Access Compliance Report

Public Rights-of-Way

(Curb Ramps)

Intersection ID: 42785	Main Street: CALDWELL_RD	Cross Street: OLD_STONE_CROSSING_DR	Location: N
ADA ID: EFECB1E38E67	Ramp Type: BlendTrans1	Initial Pass/Fail: Fail	Overall Compliance: No
Severity Score: 18.75			
Codes/Mitigation Info/Possible Solution		Field Measurements/Component Compliance

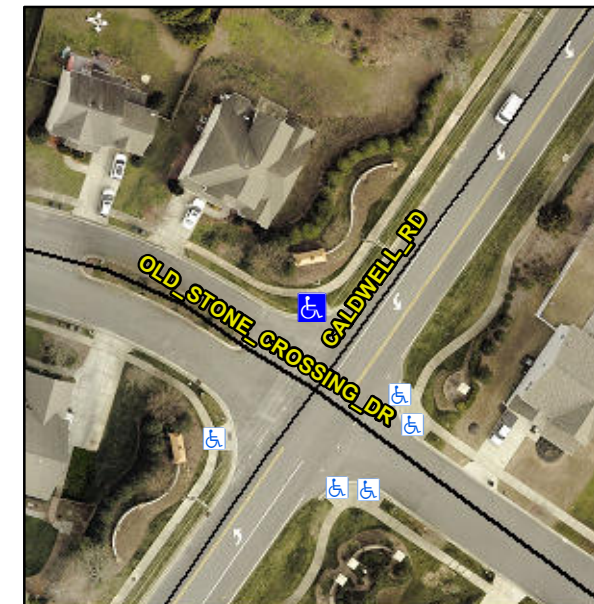
CURB LIP 1.0

Not Found, R304.5.1, R304.5.3

Compliance	Description	Data	Compliance	Description	Data
N/A	Ramp Length (in)	96.0	Yes	BlendTrans Slope (%)	4.9
No	Ramp Width (in)	34.0	No	BlendTrans XSlope (%)	2.9
N/A	Flare Type LT	N/A	N/A	Flare Type RT	N/A
N/A	Flare Slope LT (%)	N/A	N/A	Flare Slope RT (%)	N/A
N/A	Flare Traversable LT?	N/A	N/A	Flare Traversable RT?	N/A
N/A	Landing Length (in)	N/A	N/A	DWS Provided?	N/A
N/A	Landing Width (in)	N/A	N/A	DWS Contrast?	N/A
N/A	Landing Slope (%)	N/A	N/A	DWS Length (in)	N/A
N/A	Landing X Slope (%)	N/A	N/A	DWS Full Width?	N/A
N/A	Landing Curb? (Y/N)	N/A	N/A	DWS Offset (in)	N/A
N/A	Shared Landing?	N/A			
N/A	Gutter Ponding?	N/A	N/A	Gutter Slope (%)	N/A
N/A	Gutter Lip Ht (in)	N/A	N/A	Gutter X Slope (%)	N/A
N/A	Painted X Walk1?	No	N/A	Painted X Walk2?	No
	X Walk 1 Direction	To SW		X Walk 2 Direction	To SE
	X Walk 1 Width (in)	N/A		X Walk 2 Width (in)	N/A
	X Walk 1 Slope (%)	6.1		X Walk 2 Slope (%)	5.3
	X Walk 1 X Slope (%)	7.4		X Walk 2 X Slope (%)	0.3

N/A	Ramp inside XWalk1?	N/A	N/A	Ramp inside XWalk2?	N/A
	Road Slope (%)	5.5		Clear Space?	N/A
	Road X Slope (%)	9.7	N/A	Clear Space to XWalk (in)	N/A
N/A	Any Obstructions?	N/A	N/A	Storm Grate/Utility Hazard?	N/A
	Obstruction Type			Storm Grate/Utility Type	
		N/A			N/A
			Yes	Surface Condition? (G/P)	Good
			No	Curb Slope (%)	15.8

Remove & Replace Curb Ramp With Two New Directional Ramps or Equivalent.
